Southern California Edison Company
SAN ONOFRE NUCLEAR GENERATING STATION
P O BOX 128
SAN CLEMENTE, CALIFORNIA 92672

Subject: Follow-Up Activities Associated with NRC-IIT Investigation
San Onofre Nuclear Generating Station, Unit 1

3. Proposed Facility Change (PFC)/Design Change Package (DCP) 1-85-3052.OTJ. Rev. 0 (Main Control Room Indication of Main Feedwater Low Flow)

Description PROVIDE MFW LOW FLOW INDICATION IN THE MCR TO ENHANCE OPERATOR ADMINISTRATIVE CONTROL TO PREVENT WATER HAMMER WHEN THE FEEDRING IS UNCOVERED.

DCP# 3052.0TJ REV 0 SHT 15 OF 210

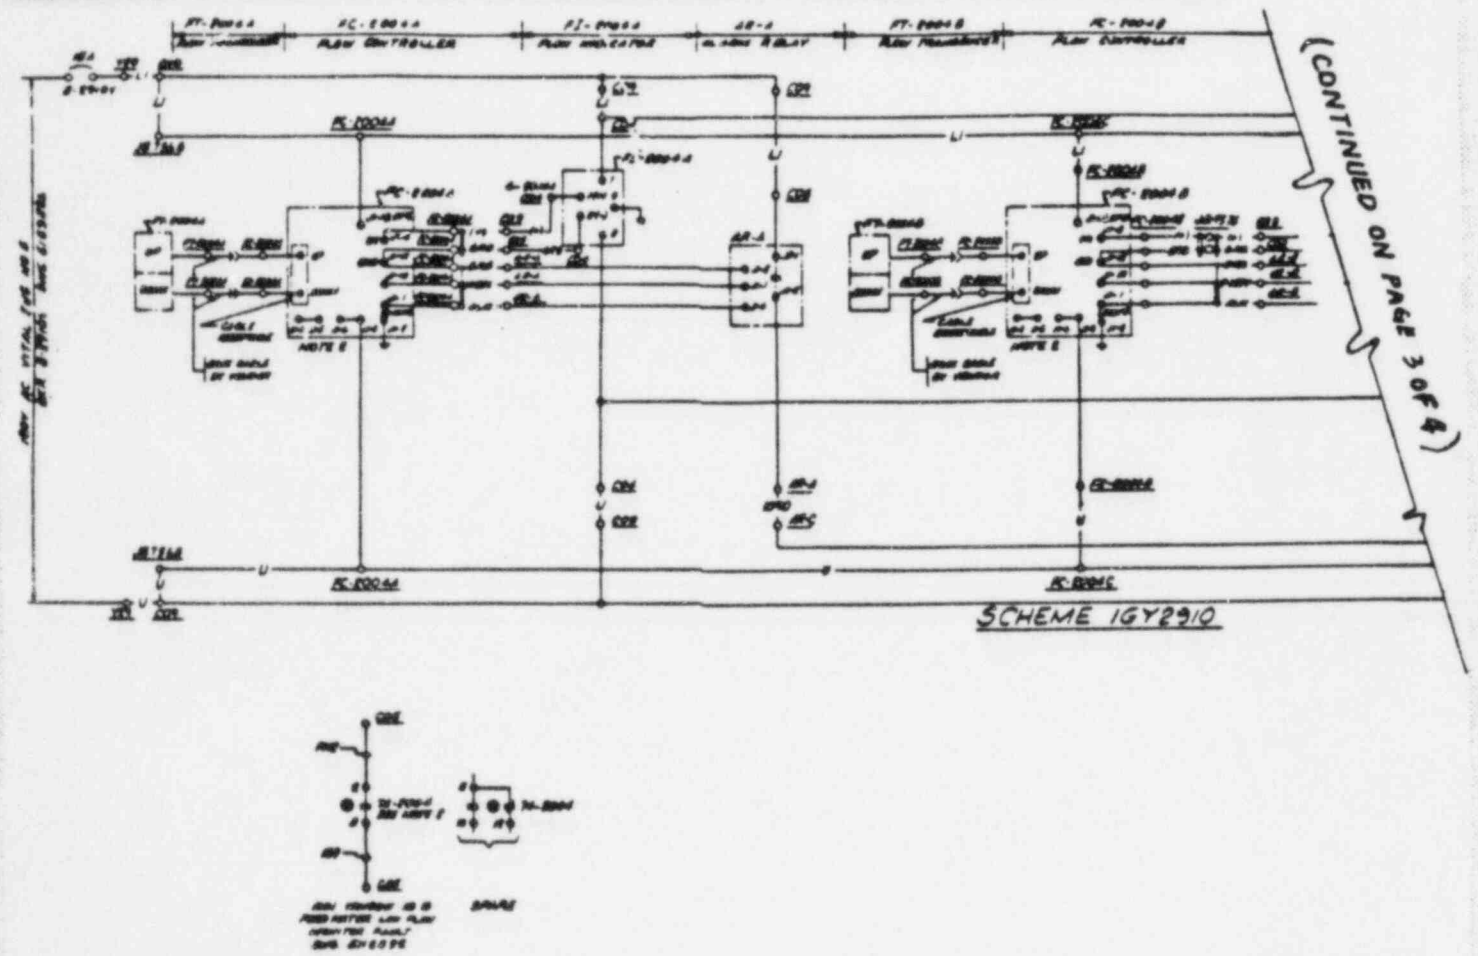
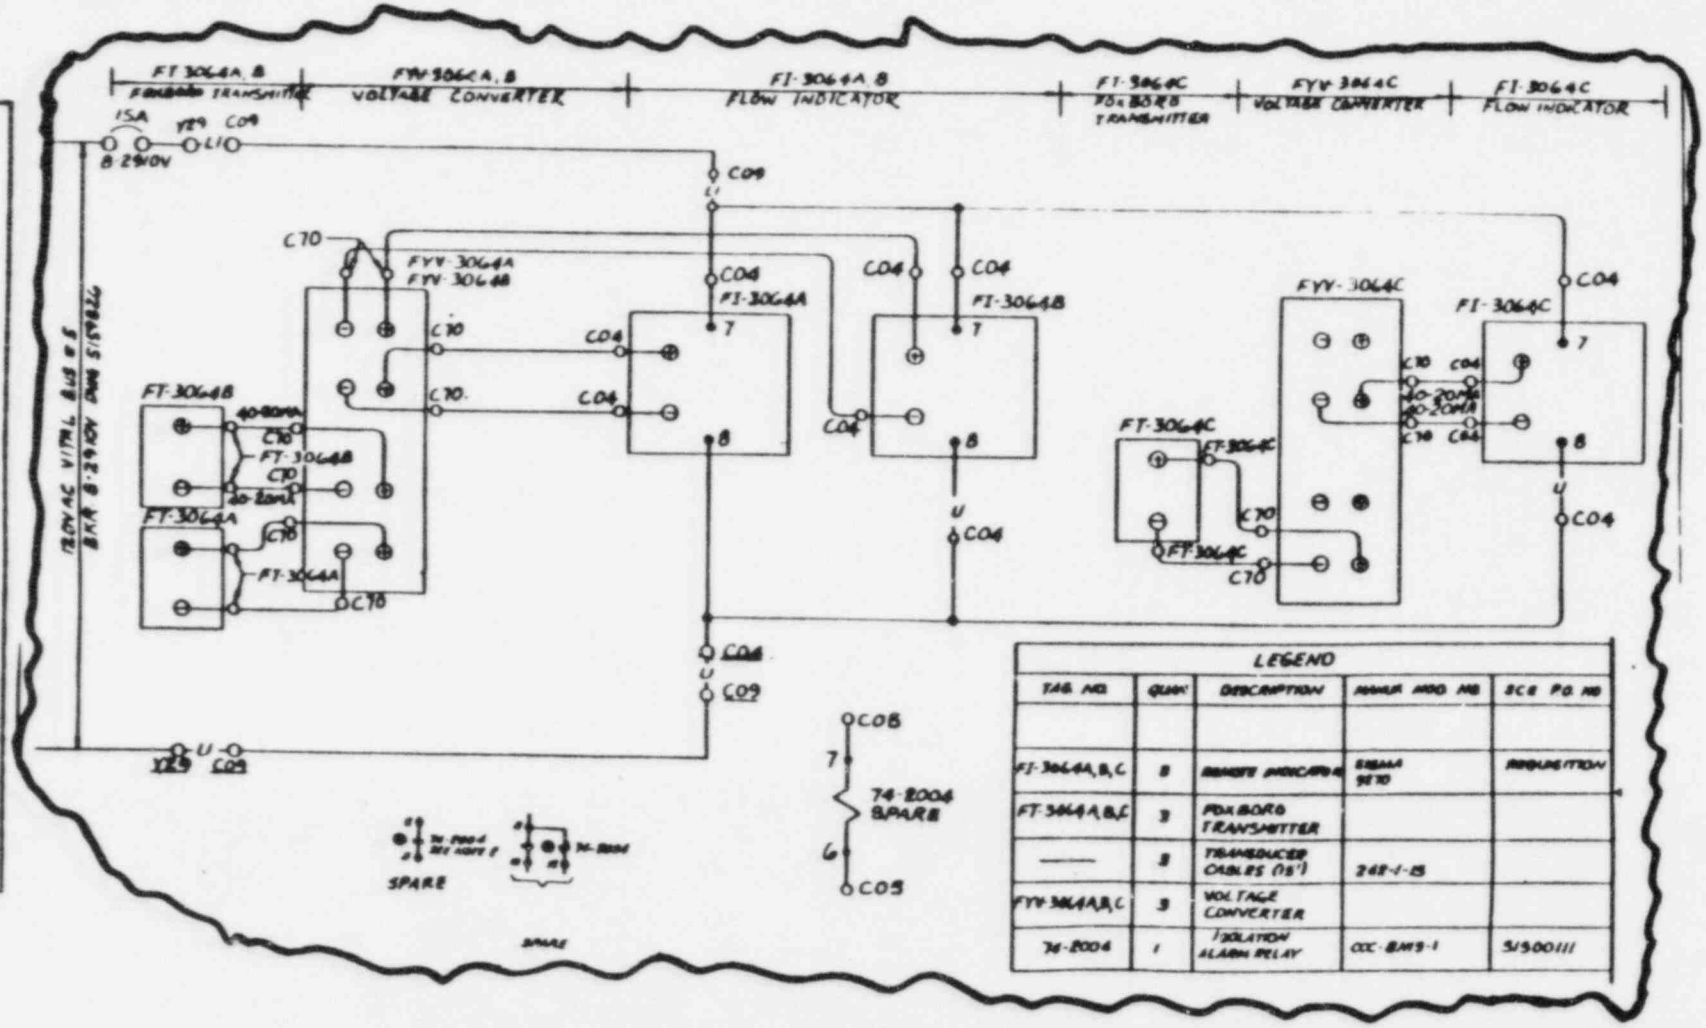
REVISE E/D DWG. 5166613 TO MAKE IT CONSISTENT WITH LOOP DIAGRAM DWG. 451337 AND TO COMPLY WITH ALL THE CHANGES NEEDED ON MAIN FEEDWATER LOW FLOW INDICATION AS MENTIONED ON SCE WORK ASSIGNMENT NO. 3052.

DETAIL 1 / N.T.S

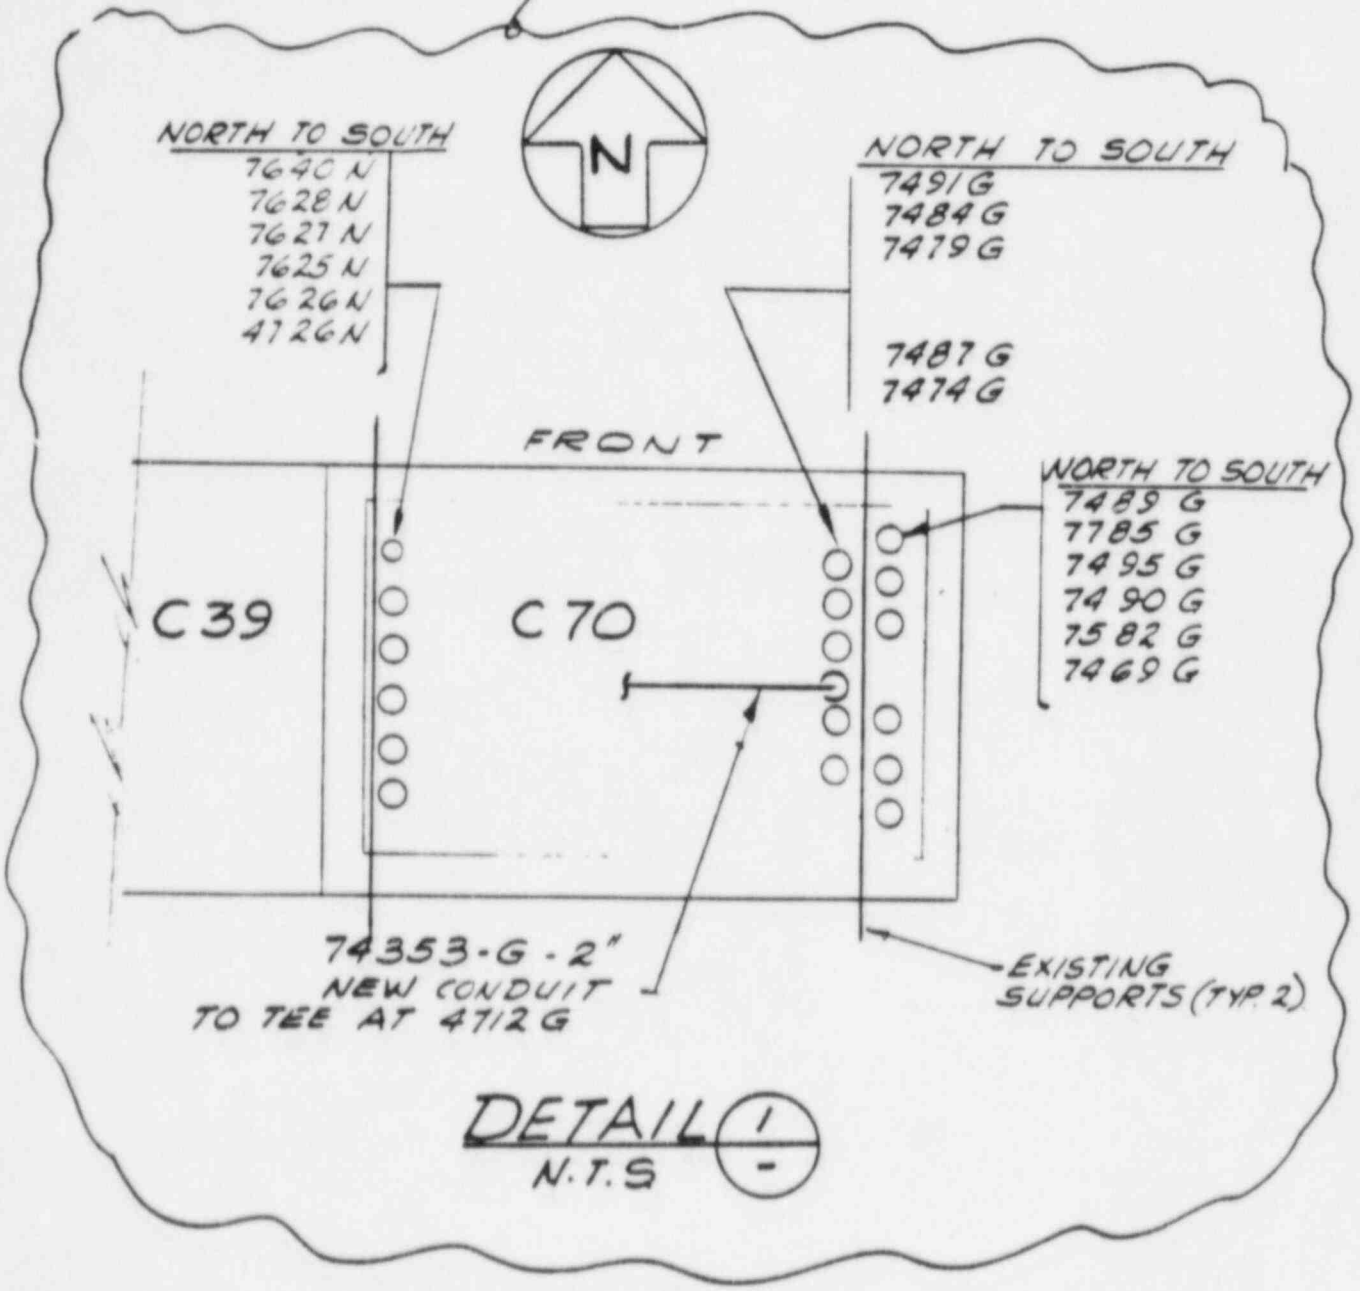
4) Add Detail-1. Conduit arrangement. Top of cabinet C-70.
